Amendment-VII dated 22.08.2025 to the RFP Documents for selection of bidder as Transmission Service Provider to establish “Transmission System for Integration of Ananthapuram-II REZ-Phase-II (3 GW)” through tariff based competitive bidding process.

Proposed Communication for "Transmission System for Integration of Ananthapuram-II REZ - Phase-II (3 GW)"

Figure F.1 R1

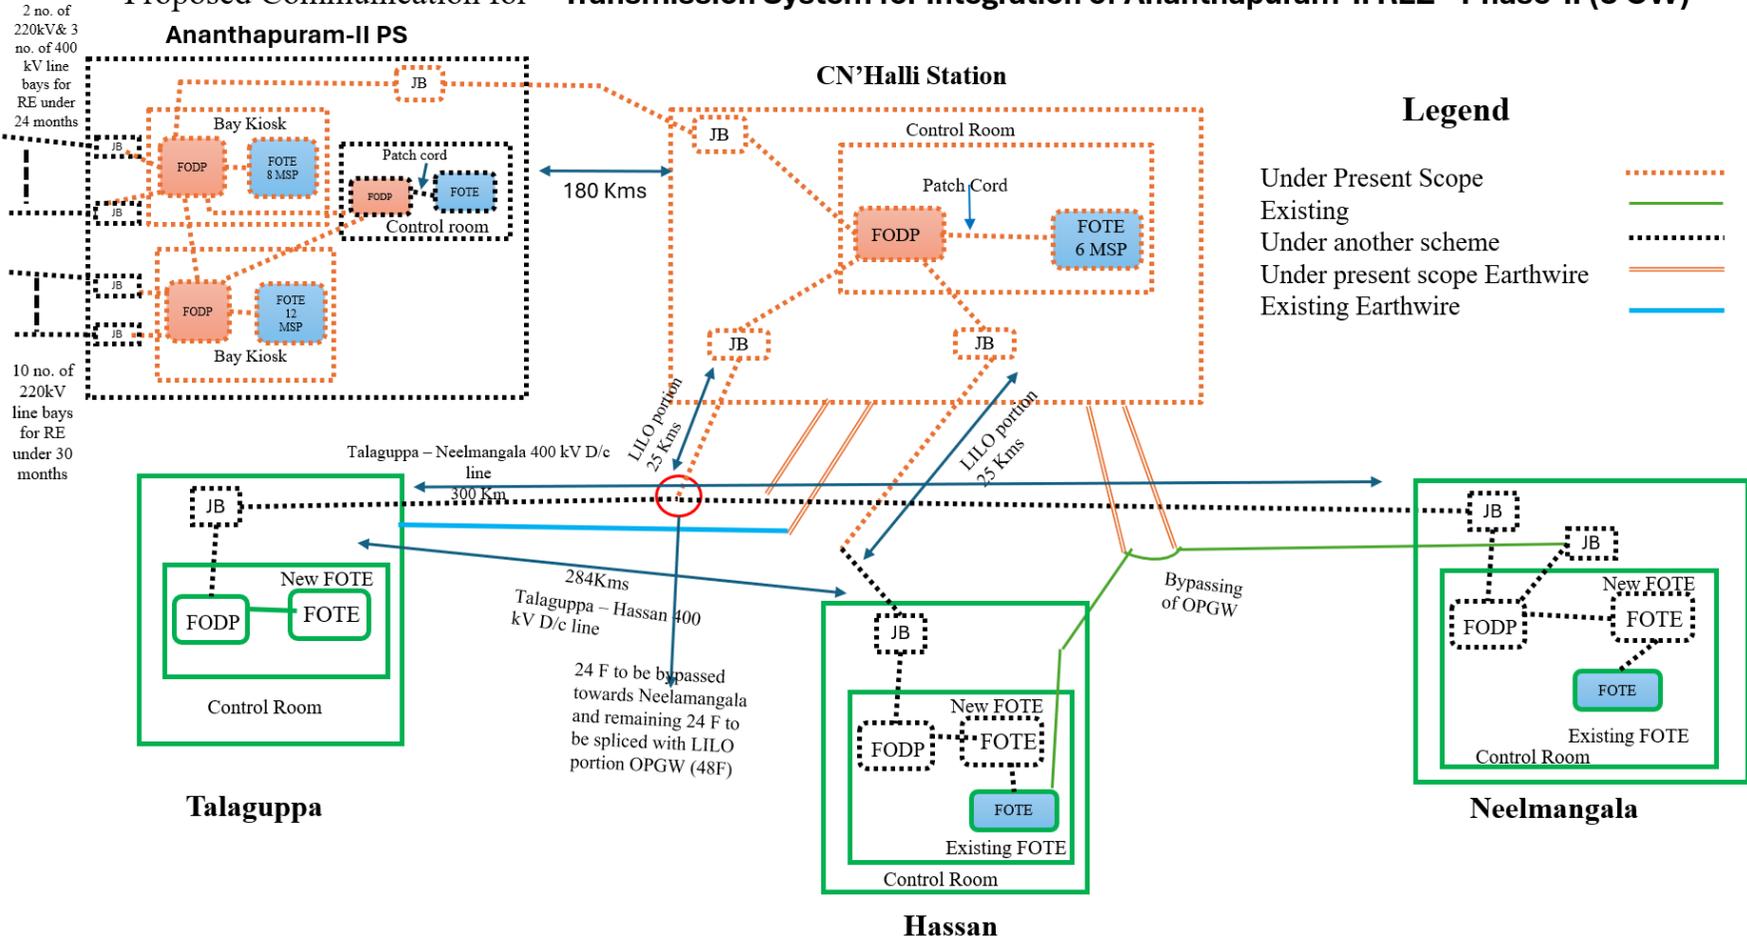
9.		Figure F.1	Revised Figure F.1 R1 attached at Annexure-I
